**SERVICE INFORMATION**

Bulletin Nbr: 811-1989  
Date:.....December 1998  
Market: all

**The soft top does not open.**

Saab 9-3 CV M98 up to and incl. chassis no. W7054661 respective X7002303.

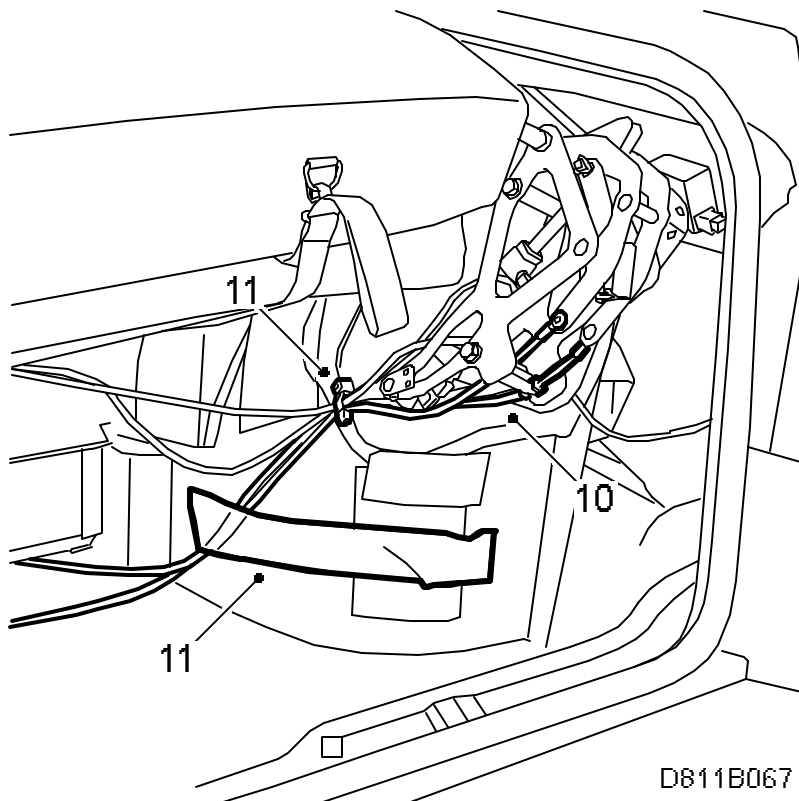
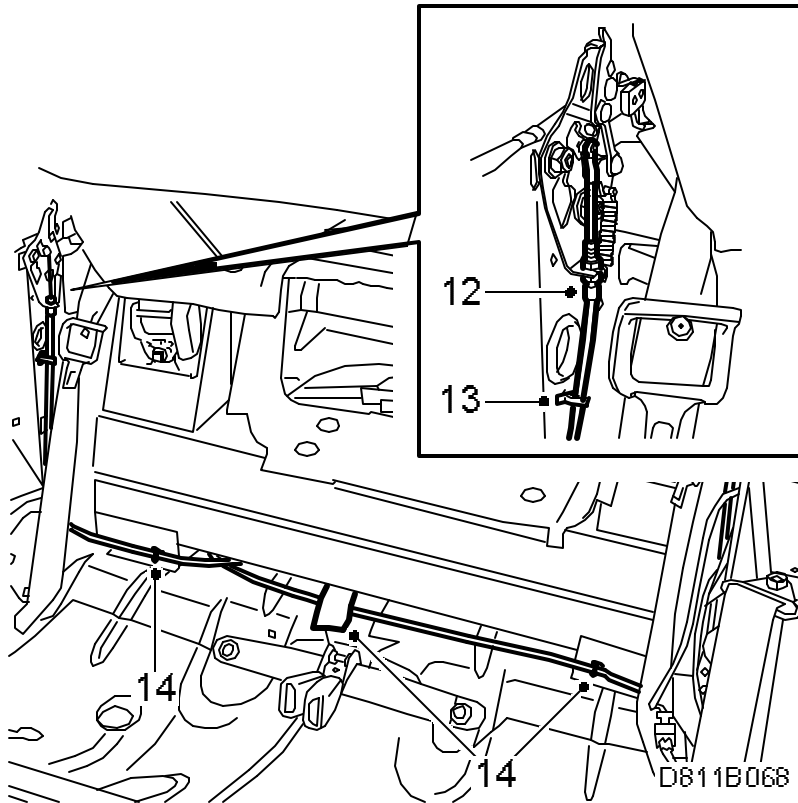
4. Loosen the lower edge of the trim towards the luggage compartment and fold it up.
5. Disconnect the cables on the right and left sides by the lock for the soft top cover. Remove the cable ties and the fabric-backed tape.
6. Hang up the stowage bag.
7. Remove the side trim on the right side and the floor mat in the luggage compartment. (The side trim on the left side does not have to be removed). See "8. Convertible 9-3, Adjustment and replacement, Luggage compartment trim". →
8. Disconnect the cables from the drive mechanism for the soft top cover, and also remove cable ties and fabric-backed tape.
9. Remove the cables.
10. Fit the new cables to the drive mechanism for the soft top cover.
11. Fit a new cable tie (part no. 48 07 939) and new fabric-backed tape.

12. Fit the cables to the lock for the soft top cover. →

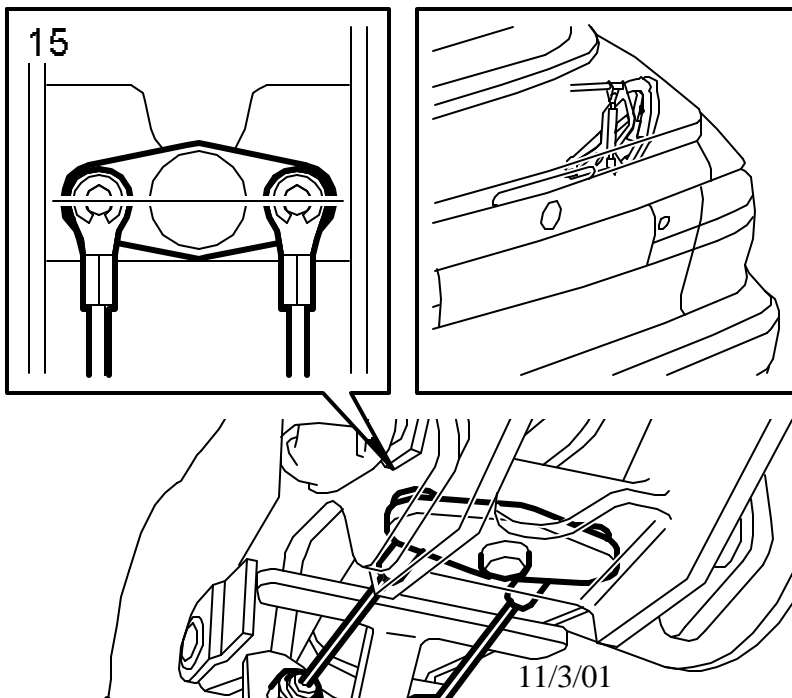
13. Fit two cable clips (part no. 85 30 917).

14. Fit two cable ties (part no. 85 52 663) and new fabric-backed tape.

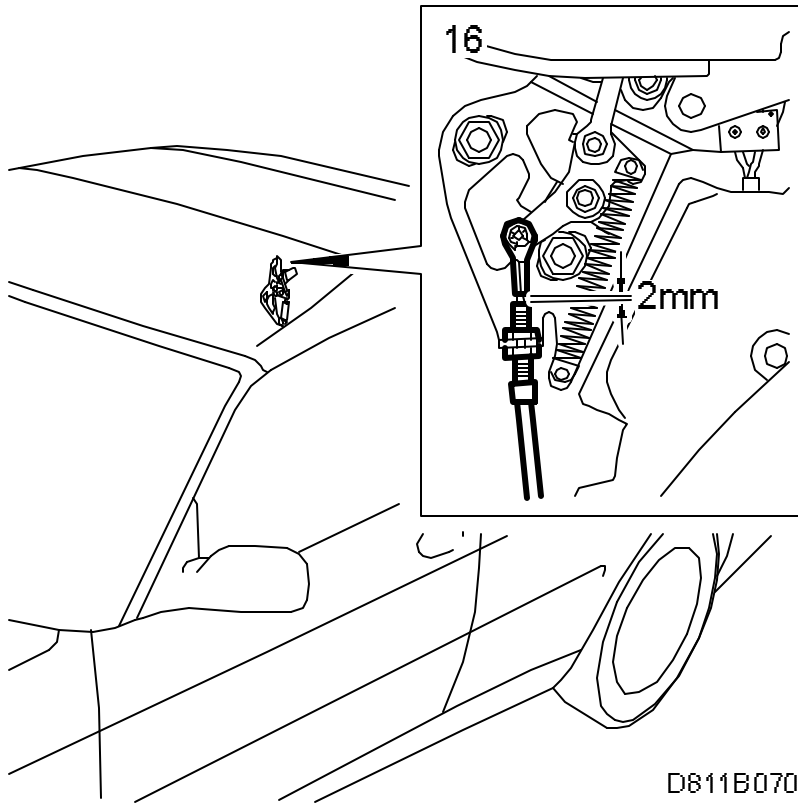
15. Adjust both cables for the soft top cover so that the lever on the drive mechanism is horizontal when the lock is locked.

D811B070

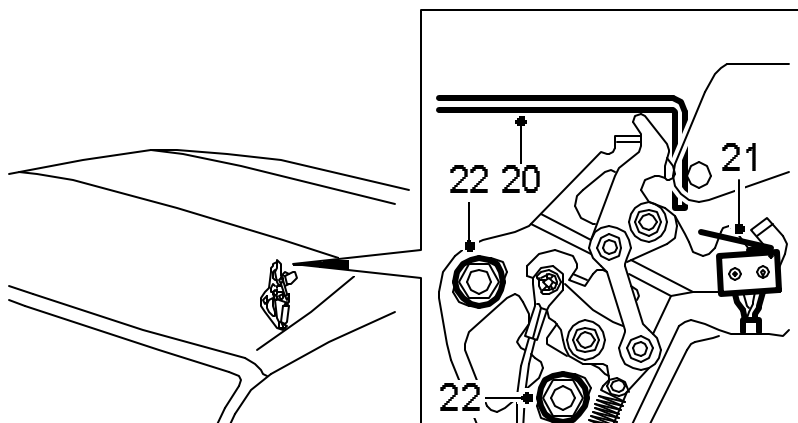
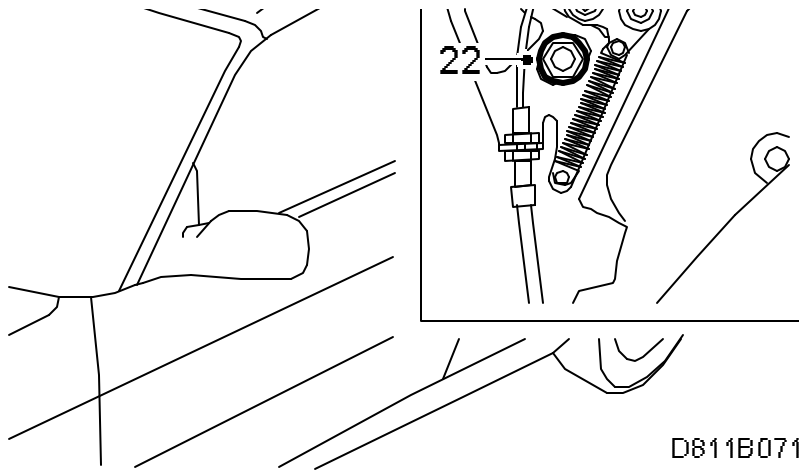
- 16. Check that the distance between the cable adjustment and the end of the cable is at least 2 mm.

- 17. Adjust the cable using the cable adjustments by the locks.
- 18. Check that the locks open completely.
- 19. After fitting the new cables, also check the lock for the soft top cover and, if needed, adjust.
